Dallas to Houston High-Speed Rail

Final Environmental Impact Statement

ERRATA AND UPDATED INFORMATION

Dallas Terminal Area Map

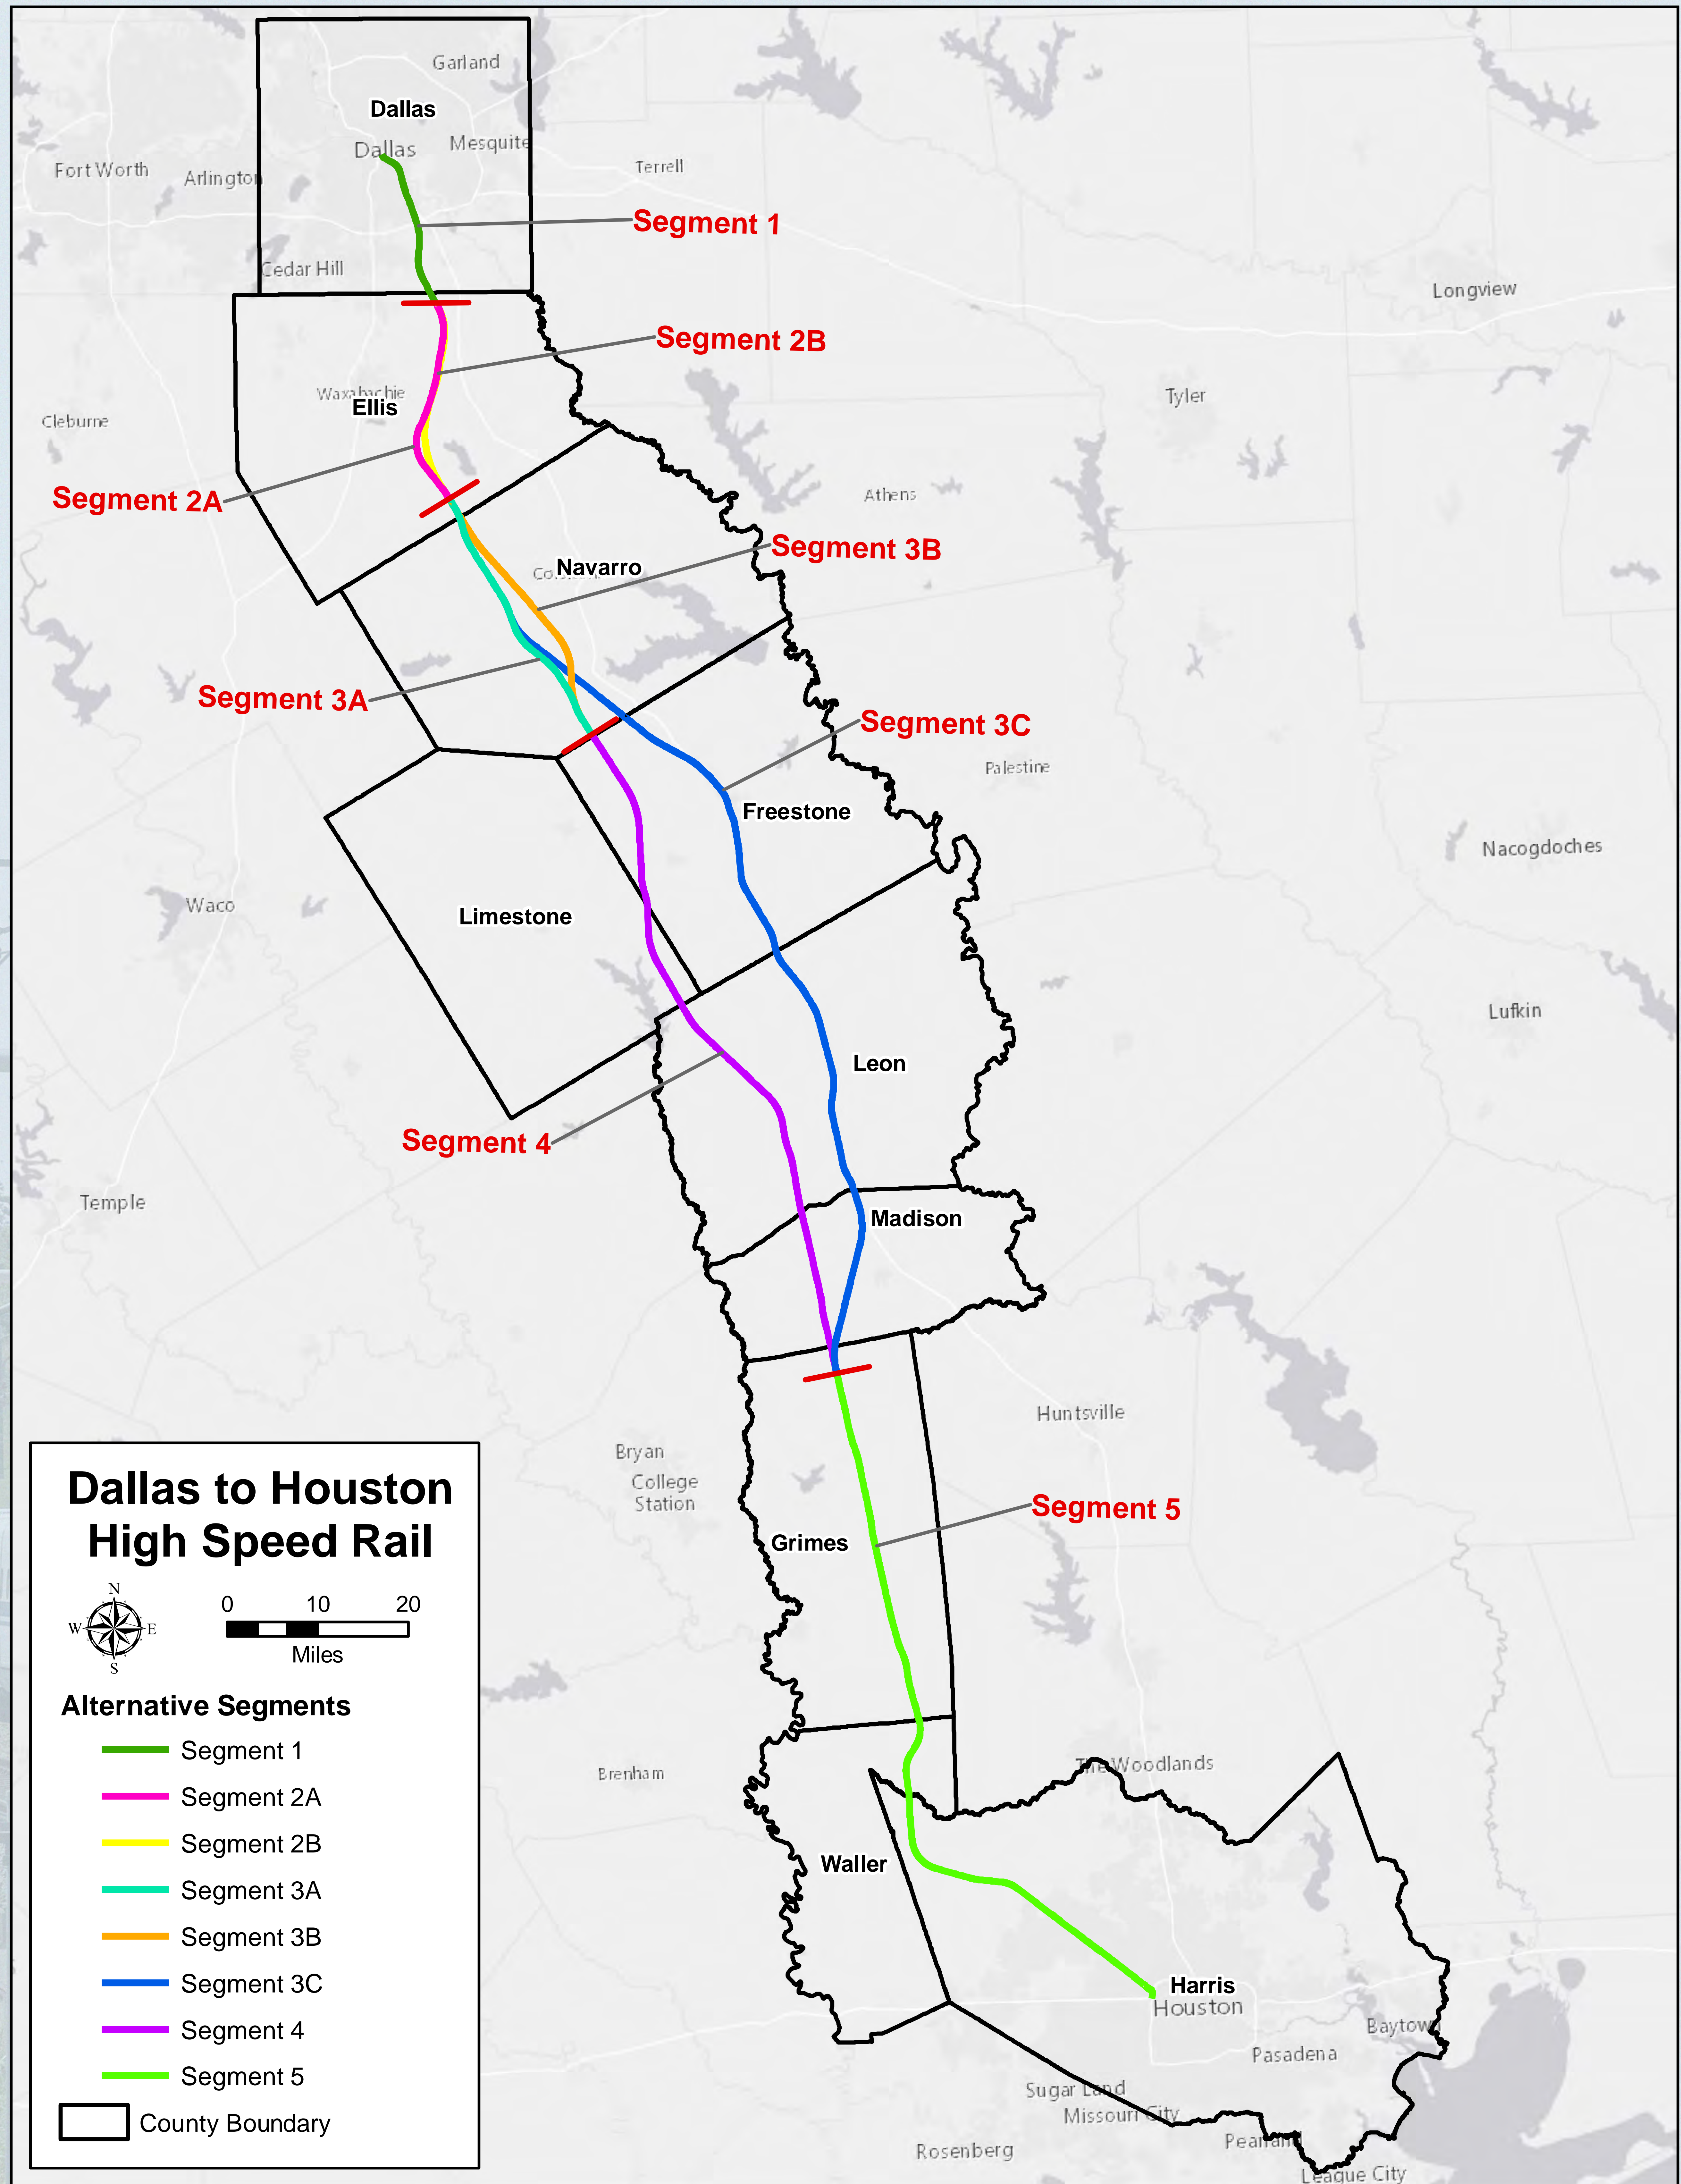
ES.4 Alternatives Analysis and 2.5.3 Initial Trainset Maintenance Facility Alternatives	ES-10 and 2-38	Clarification was added to better explain Dallas TMF location identification.	<p><i>Text is clarified as shown:</i></p> <p>TCRR proposed two locations for the TMF in Dallas County, the Dallas North TMF and Dallas South TMF. The Dallas North TMF site would be located north of IH-20 within the City of Dallas, about 7.5 miles from the Dallas Terminal Station. The Dallas South TMF site would be located north of Belt Line Road, approximately 12 miles from the Dallas Terminal Station. The Dallas South TMF would require an additional MOW facility between the TMF and the Dallas Terminal Station, while the Dallas North TMF site would not. For the Draft EIS, FRA evaluated these Dallas locations. However, TCRR's ongoing coordination with stakeholders indicated that the Dallas International Intermodal Terminal¹ and related developments in south Dallas have continued to progress since the release of the Draft EIS. Because of</p>

Location/Section in Final EIS	Page in Final EIS	Issue	Correction or Update
			<p>these ongoing developments, TCRR identified the North location for the Dallas TMF, because it would better integrate with the City of Dallas infrastructure determined that the Dallas South TMF site was not a viable option for the Project, as indicated in Section 2.5.4, Engineering Refinements. Both the Dallas North and South TMF sites based on TCRR’s updated Project LOD are assessed in this Final EIS.</p> <p>_____</p> <p>³ The City of Dallas invested into the infrastructure of the International Inland Port of Dallas, which includes the Dallas International Intermodal Terminal and other public-private partnerships. https://www.dallasecodev.org/414/International-Inland-Port-of-Dallas</p>
<p>ES.6.2.3 General HSR Program Refinements and Optimizations and 2.5.4.1 Engineering Refinements between Draft and Final EIS</p>	<p>ES-14 and 2-44</p>	<p>Clarification was added to better explain Dallas TMF location identification.</p>	<p><i>Text is clarified as shown:</i></p> <p>Dallas TMF: The Draft EIS identified the Dallas South TMF site as the preferred location; however, following the publication of the Draft EIS the Dallas International Intermodal Terminal⁴ and related developments in south Dallas advanced and created conflicts with precluded the development of a TMF at the Dallas South TMF location. Therefore, TCRR identified the North location for the Dallas TMF, because it would better integrate with the City of Dallas infrastructure. Consequently, the Dallas North TMF is the only remaining viable location for the Dallas TMF.</p> <p>_____</p> <p>⁴ The City of Dallas invested into the infrastructure of the International Inland Port of Dallas, which includes the Dallas International Intermodal Terminal and other public-private partnerships. https://www.dallasecodev.org/414/International-Inland-Port-of-Dallas</p>
